1. Section 3.2 last para: The statements for the AEP of the Somerset floods only apply for the overall Wivenhoe catchment floods. What are the AEPs for the Somerset catchment floods?
2. Section 3.3 middle para: Is the reference to Section 2.6 correct? Shouldn't it refer to Section 2.8 and the use of reasonable discretion?
3. Section 8.4 talks about the strategy being chosen based on predictions, maximums and peaks as below:

Wivenhoe Flood Strategy Flow Chart

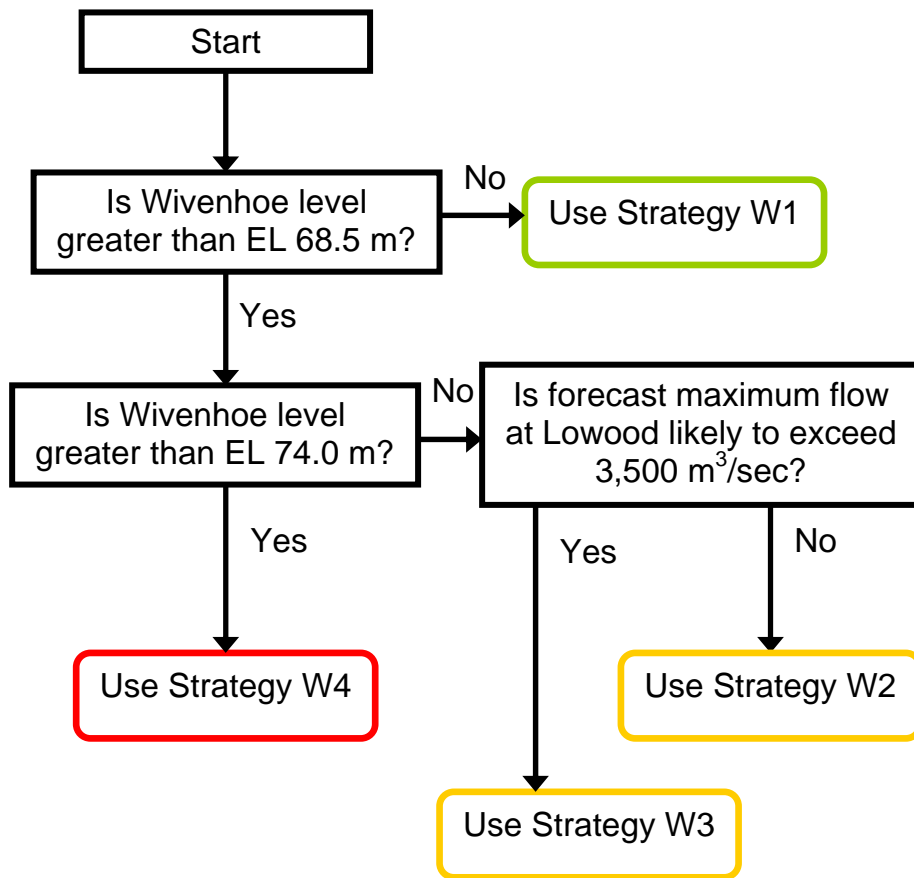
Our understanding is that the actual values are used to select W1 to W4 with some variations allowed for based on forecasts. e.g. You transition from W1 to W2 or W3 once the water level in Wivenhoe exceeds EL 68.5m. The choice between W2 and W3 is made on the forecast of the peaks depending on whether the Lowood or the Moggill flows control.

4. From this perspective, it may be better to change the figure on page 27 to something along the following lines.

5. All W strategies should refer to actual levels and flows and not the predicted levels and flows. Then W4A and W4B can be differentiated based on Predicted Maximum Lake Level.

I think there needs to be another criterion under Procedures W2 and W3 of not less than $1900 \text{ m}^3/\text{s}$ given for the target maximum flows. Otherwise if for example the natural peak flow at Lowood excluding Wivenhoe releases was only $1000 \text{ m}^3/\text{s}$ that becomes the target maximum flow there.

It may also be useful to specify that the peak outflow should not exceed the peak inflow (i.e the total inflow into Wivenhoe including Somerset outflows).
